Feb 24, 2025

On or about December 4, 2024, I mailed about 175 letters to neighbors around 2281 Kersey Road and 1736 Winchester Road. I received 9 responses. Thank you to everyone who took the time to respond. It was extremely helpful. Please see attached a number of new "Draft Concept Plans", based on:

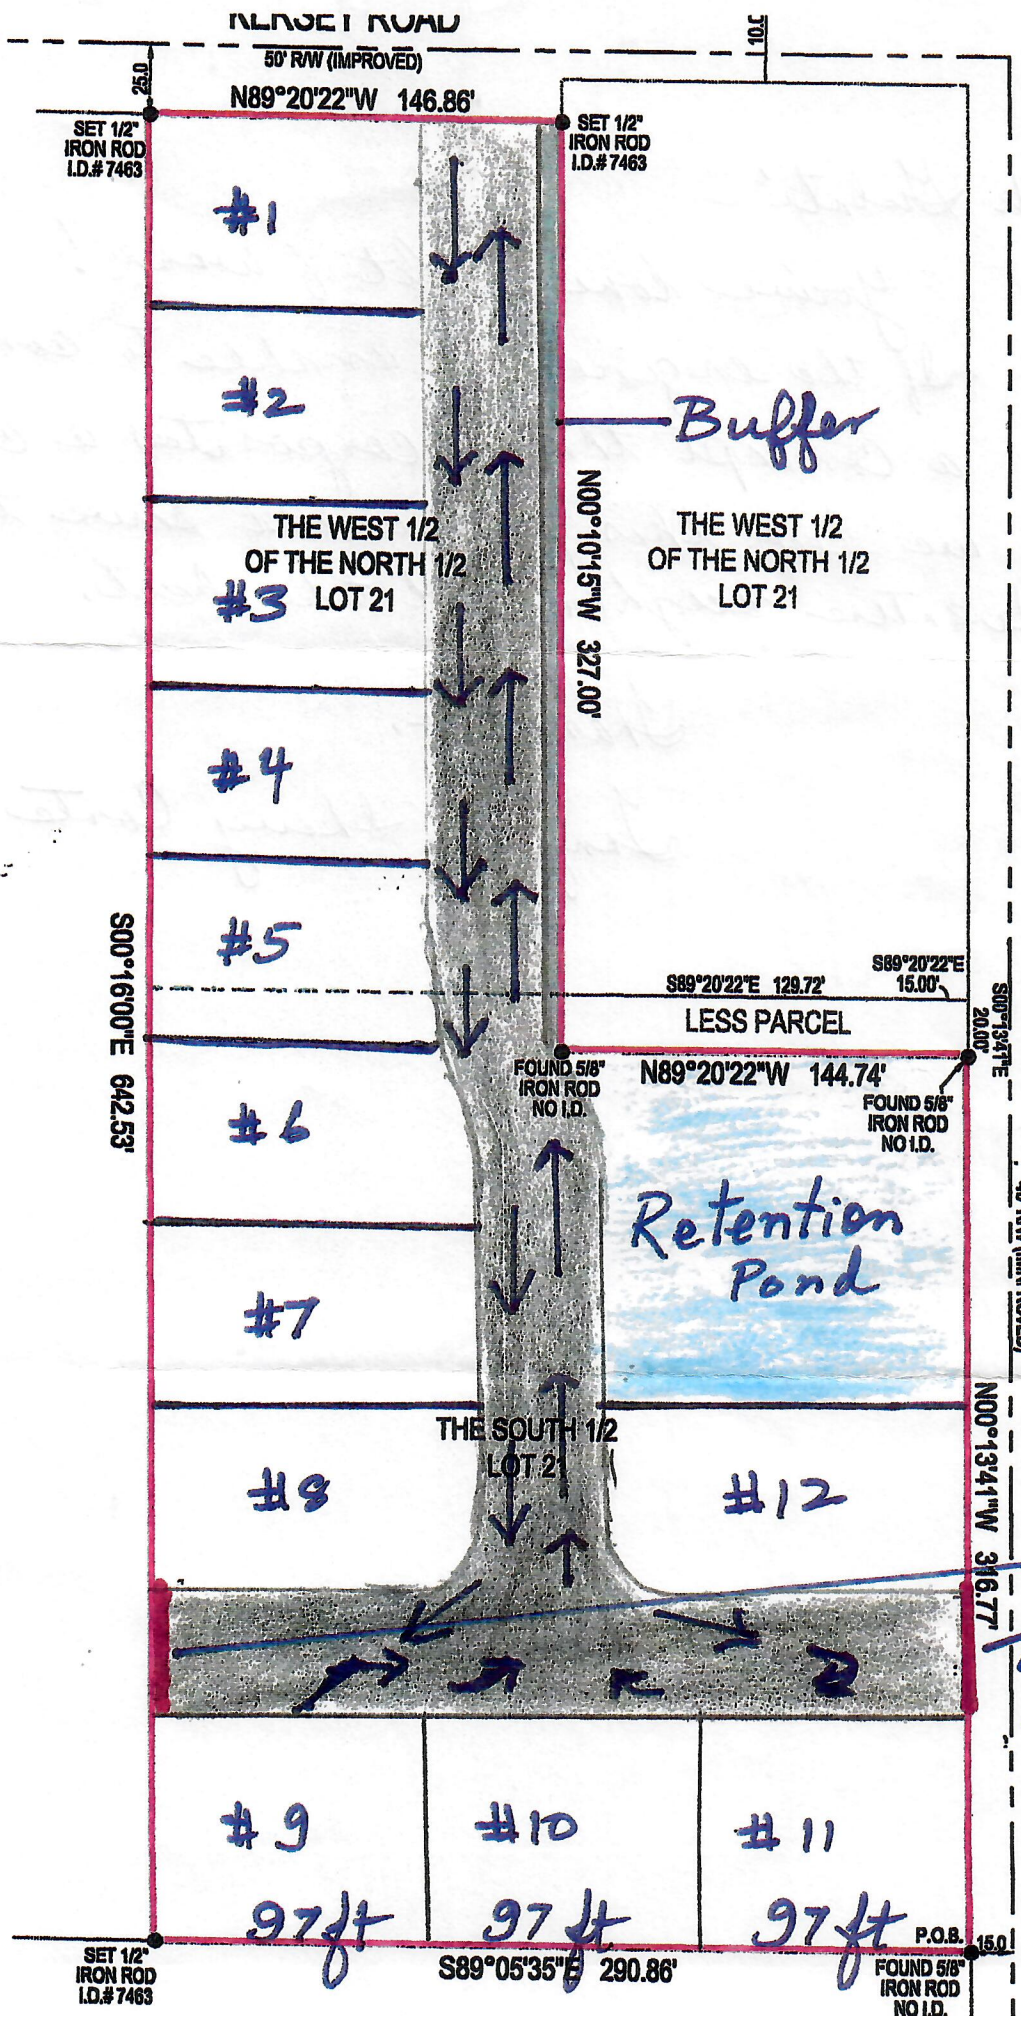
If the engineer is unable to configure  
a concept that incorporates a cal-de-see,  
we feel this plan would serve the integrity of  
the entire neighborhood the best.

Emergent  
Ingrers  
&  
Egense  
only
